Subject: UniStar Nuclear Energy, NRC Docket No. 52-016
Response to Request for Additional Information for the
Calvert Cliffs Nuclear Power Plant, Unit 3,
RAI 353, Determining the Technical Adequacy of Probabilistic Risk Assessment
Results for Risk-Informed Activities

**Response to NRC Request for Additional Information
RAI 353, Question 19.01-1, Determining the Technical Adequacy of
Probabilistic Risk Assessment Results for Risk-Informed Activities,
Calvert Cliffs Nuclear Power Plant, Unit 3**

RAI No. 353

Question 19.01-1

FIGURE 1: Ground Motion Response Spectra (GMRS) of the CCNPP Unit 3

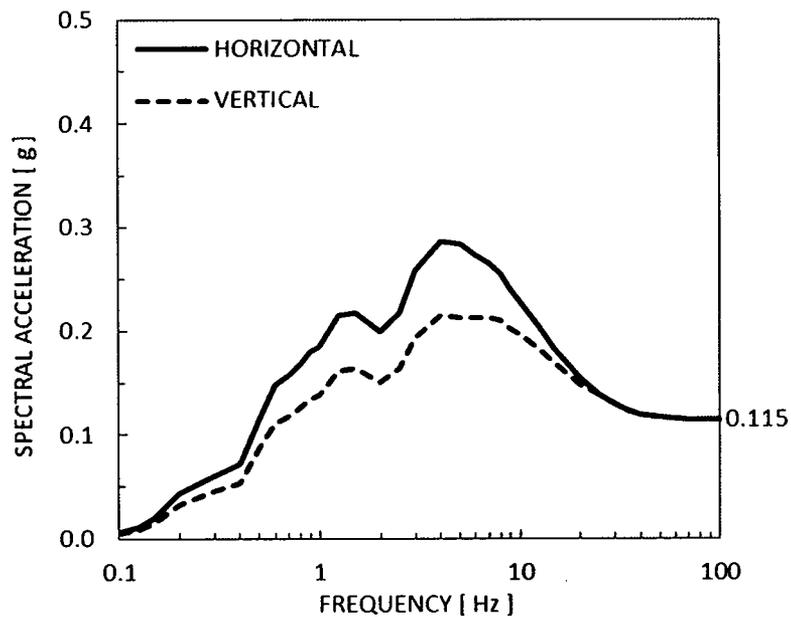
1. The response stated that the GMRS is anchored to a PGA of 0.076g which is inconsistent with a previous response to RAI 160, Question 19-19 which stated that the CCNPP Unit 3 ground motion response spectra (GMRS) peak ground acceleration is 0.084 g.

The Probabilistic Seismic Hazard Analysis (PSHA) for the Calvert Cliffs Nuclear Power Plant (CCNPP) Unit 3 has been updated to incorporate the recently developed 2012 Central and Eastern United States (CEUS) Seismic Source Characterization (EPRI/DOE/NRC, 2012). Both the previously reported values of the Peak Ground Acceleration (PGA) of the Ground Motion Response Spectra (GMRS), 0.076 g and 0.084 g, have been superseded by the result obtained with the use of the 2012 CEUS characterization. The updated and current value of the PGA associated to the CCNPP Unit 3 GMRS is 0.115 g. For illustration purposes, Figure 1 provides the GMRS of the CCNPP Unit 3.

FIGURE 2: CCNPP Unit 3 GMRS (Horizontal) and U.S. EPR Certified Seismic Design Response Spectra (CSDRS)

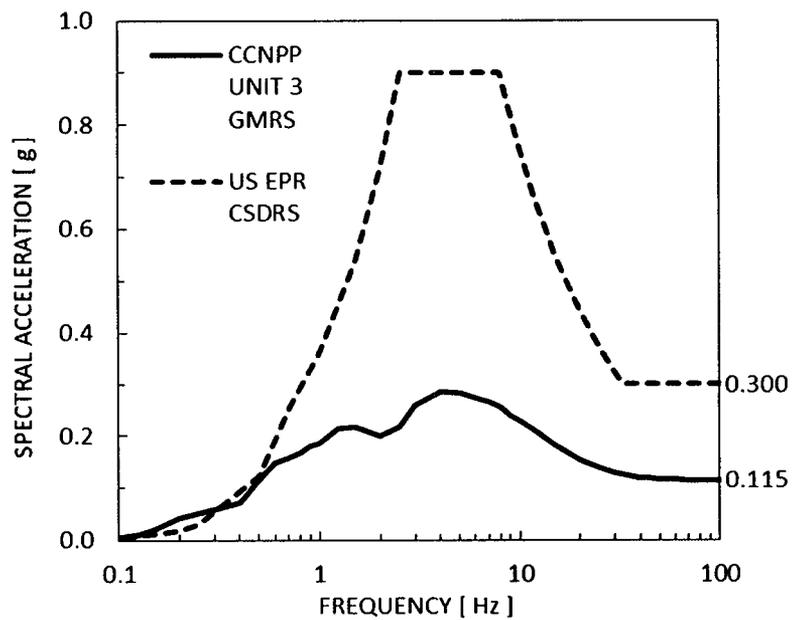
3. The DC fragility analysis is based on the assumed site parameters and typically does not consider soil related failure modes. Therefore, the HCLPF (high confidence low probability of failure) capacity for the EPR DC portion of Structures, Systems and Components (SSCs) was established at 0.5g PGA (Based on CSDRS shapes). It is not clear in the response whether the applicant is confirming the plant level seismic capacity at 1.67 times CSDRS HCLPF capacity or at the site-specific 1.67 times GMRS HCLPF capacity for the Calvert Cliff site.

Given the low seismicity of the CCNPP Unit 3 site with respect to the U.S. EPR Certified Seismic Design Response Spectra (CSDRS) (Figure 2), the CCNPP Unit 3 SMA update approach is based on the screening of rugged site specific effects and plant specific components of the CCNPP Unit 3 site. The screening considers the GMRS, or Foundation Input Response Spectra (FIRS), as applicable, with the PGA scaled by a factor of 1.67. A successful screening of the site specific effects and plant specific components decouples such effects and components from the U.S. EPR SMA and, therefore, it is possible to develop the CCNPP Unit 3 site specific SMA update independent of the finalization of the U.S. EPR PRA.

Figure 2 indicates that the GMRS exceeds the CSDRS at the very low frequency range ($f \leq 0.3$ Hz). The exceedances are present at the ISRS level to a lesser degree. The seismic demand associated with the site specific effects and plant components is driven by the seismic response of civil structures. Civil structures and their design are not impacted by the demands that correspond to very low frequencies and their associated low acceleration levels. Issues such as structural design, structural sliding, and bearing demand, are controlled by higher frequencies. Other analyses, such as liquefaction and slope stability, are dependent on the PGA only. Therefore, the screening of civil/structural rugged components is not impacted by the exceedances at the very low frequency range.

FIGURE 3: AB base shear obtained with the ZPA and TH approaches

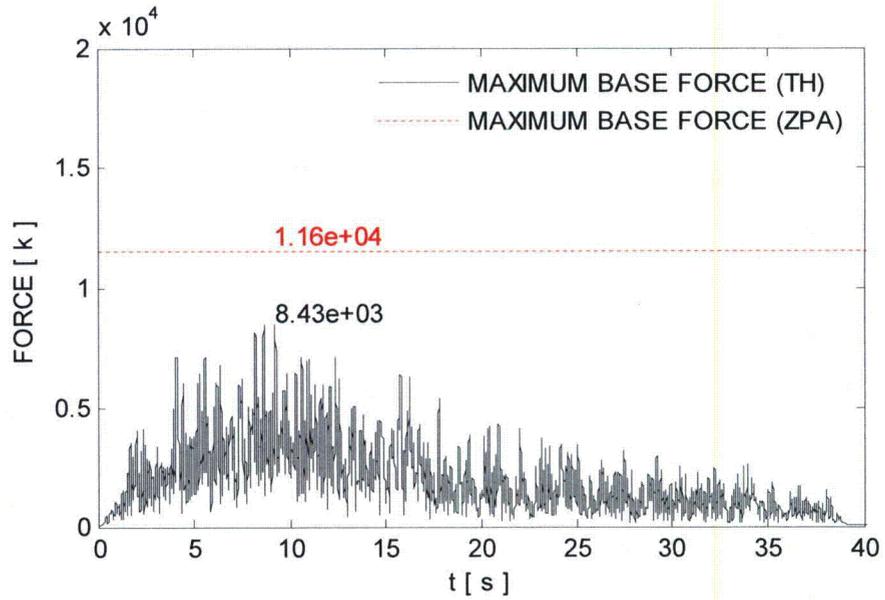
4. The DC fragility analysis establishes the HCLPF capacity for the SSCs in system model at 1.67 times CSDRS using a generic site which does not address site-specific soil failures. Therefore, for soil site, the applicant needs to confirm whether the DC HCLPF calculations remain valid for the site or update them using the site-specific GMRS to confirm the plant level HCLPF at 1.67 times GMRS. It is not clear from the response that the applicant has done it. In addition, AREVA has not yet completed the DC fragility analysis for the SSCs. Therefore, it may not be possible for the applicant to perform the fragility update until the DC's analysis is complete.

As discussed below, by removing only the first conservatism listed above, the FOS will increase by more than 35%, from 1.38 to 1.89.

Inter-story forces of the AB are calculated by multiplying the story masses times the ZPA. The maximum base horizontal shear is obtained after performing a Square Root Sum of the Squares (SRSS) combination of the orthogonal ZPA related forces. The resulting base shear is conservative since it is obtained with the assumption that seismic forces act at their maximum magnitude, at the same moment in time, and toward the same direction. The SRSS combination of orthogonal forces always use the maximum ZPA related values of each direction. In order to obtain an estimate of the FOS without the incorporation of this conservatism, horizontal forces are combined at each time step and the maximum force is obtained as the maximum recorded throughout the time history. This approach is referred to as the time history (TH) approach.

Figure 3 illustrates the relationship between the ZPA and the TH approaches by comparing the total base shear. Figure 4 illustrates the relationship between the design basis FOS and the FOS that is estimated from a time history analysis.
